## SERVICE INSTRUCTION

# Running modifications of the Bing constant depression carburetor for ROTAX® Engine Type 912 and 914 (Series) and 582 UL mod. 99/mod. 17 (Series)

ATA System: 73-00-00 Fuel system

Fig. 1  
Throttle valve levers OLD and NEW

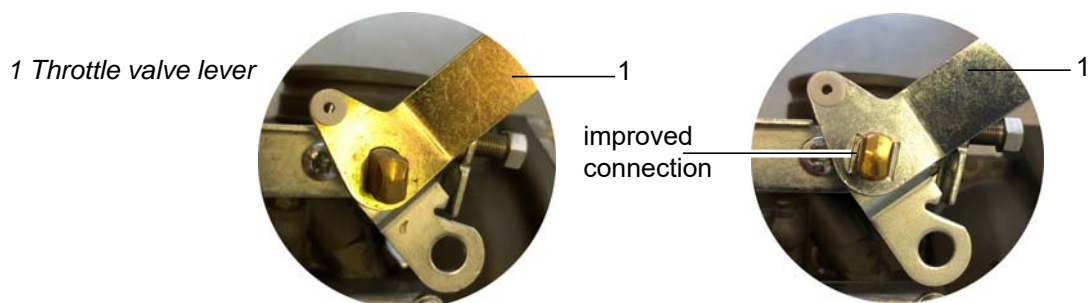
Throttle valve levers (1) were changed to a pressed notch style which provides improved connection to the throttle valve shaft. For the revised throttle levers part no. 963026 for the 1/3 carburetor and part no. 963021 for the 2/4 carburetor.

Fig. 2  
Float chamber assy.

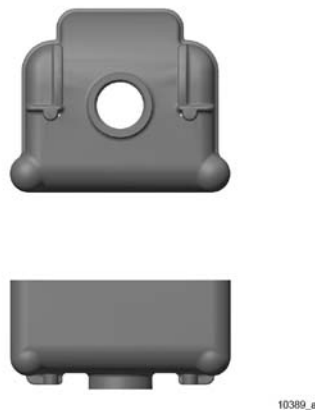
The float chamber assembly has been changed from Zinc die-cast material coated with a sealing agent, to anodized Aluminum die-cast material.

This provides better resistance against contamination, such as aged fuel or water corrosion etc.

NOTE: Float chamber assy. do not have to be replaced as a pair. Meaning it is acceptable to mix old and new float chambers on the same engine.

Fig. 3

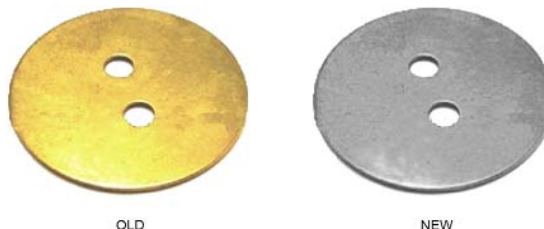
The throttle valve was changed to a machining process instead of die cutting process.

The part number for the throttle valve is 963666.

Fig. 4

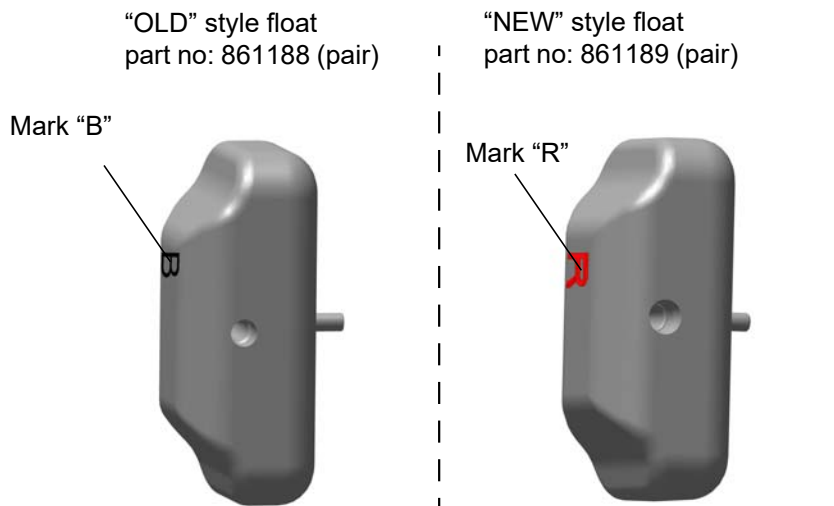
New floats pair part no. 861189 has been introduced as of:

The new floats are not marked with any identification “dots”, but instead of a “B” they have an “R” identification mark.

As per Maintenance Manual Line (MML) let the floats dry for 1-2 minutes. Only weigh dry floats. In no case the max. weight (of both floats together) is allowed to exceed 7 grams (0.0154 lb.). This applies to all floats, old and new.

NOTE: Carburetor floats must be replaced as a pair.

Fig. 10  
Carburetor overview (912 Series)

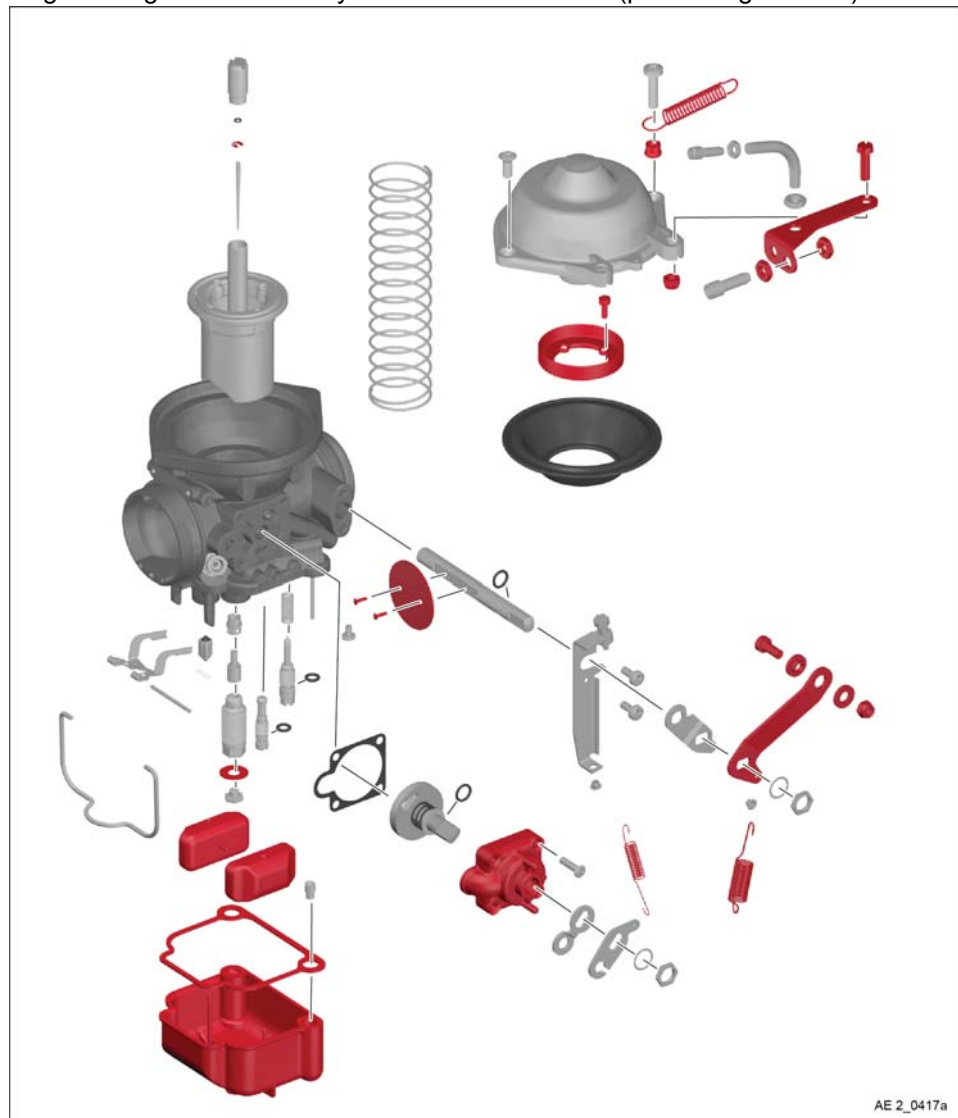
NOTE: Due to changing regulations all individual parts listed below are now free of CR6+ chromium.

The material of the float chamber gasket was changed to a Viton based material with new part no. 830721 and 830722. This new gaskets can be used instead of previous paper or cork gaskets part no. 830720 / 830724 / 830728.
